PLANNING CLEARANCE
(Single Family Residential and Accessory Structures)
Grand Junction Community Development Department

BLDG ADDRESS 2854 Picardy Dr TAX SCHEDULE NO. 2943-071-08-018
 SUBDIVISION Rothhaupt SQ. FT. OF PROPOSED BLDG(S)/ADDITION 1490
 FILING _____ BLK 3 LOT 10 SQ. FT. OF EXISTING BLDG(S) _____
 (1) OWNER Kelley Dearth NO. OF DWELLING UNITS BEFORE: _____ AFTER: 1 THIS CONSTRUCTION
 (1) ADDRESS 12310 W 42nd Ave Denver 80033 NO. OF BLDGS ON PARCEL BEFORE: _____ AFTER: 1 THIS CONSTRUCTION
 (1) TELEPHONE 303-420-6138 USE OF EXISTING BLDGS _____
 (2) APPLICANT Same DESCRIPTION OF WORK AND INTENDED USE: _____
 (2) ADDRESS _____
 (2) TELEPHONE _____ new residence

Re: Lot 10, BLOCK THREE, Rothhaupt Subdivision

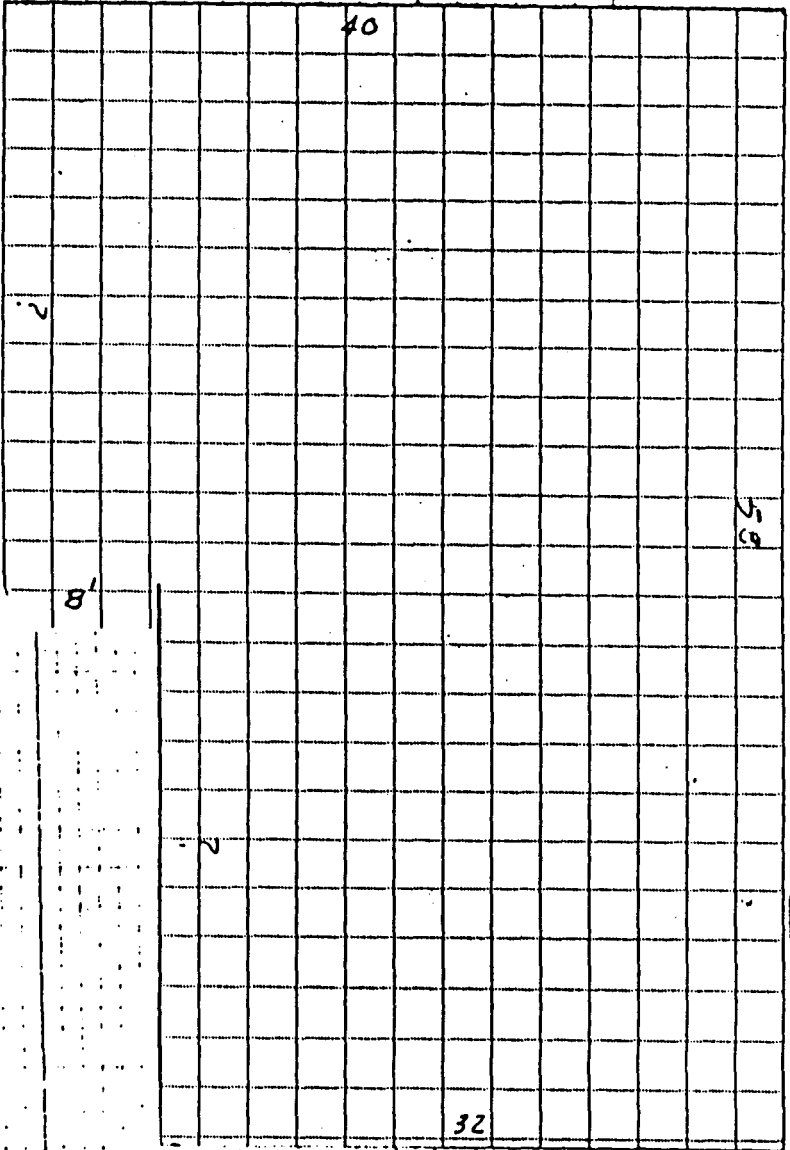
The plan sketch of the lot, the existing Grand Junction Drainage District easement, and a proposed house footprint have been reviewed by the Drainage District staff. The proposed house seems to be off of the easement by about a foot. The site plan is acceptable as far as the Drainage District is concerned.

There was inquiry about a patio or deck which might intrude into the easement. Any ground level improvement which might be built upon, such as a patio, is strongly discouraged. A deck which can be removed or relocated easier than a portion of a house or another permanent structure is preferred.

Replacement of the tile line in the near future is not foreseen. However, through the expected life of the house and the tile line they both will require maintenance. Access to the tile line and least interruption to the home owner will result if all improvements within the easement are kept to a minimum. The idea of minimum improvements within the District's easement could be accomplished by some notification to the new home owner in the fashion of an acknowledgement about the easement as a part of the real estate closing papers. Rather than rely upon a person reading the book and pages referenced in Schedule B of the Title Policy, a photocopy of the easement and restrictions could be provided to the new owner.

A long term resolution to the problem of where to site a house on the lot would be for a City front yard variance. Board of Adjustment relaxation of the front yard setback will be actively supported by the Drainage District. The location of the existing tile line really limits the use of the lot.
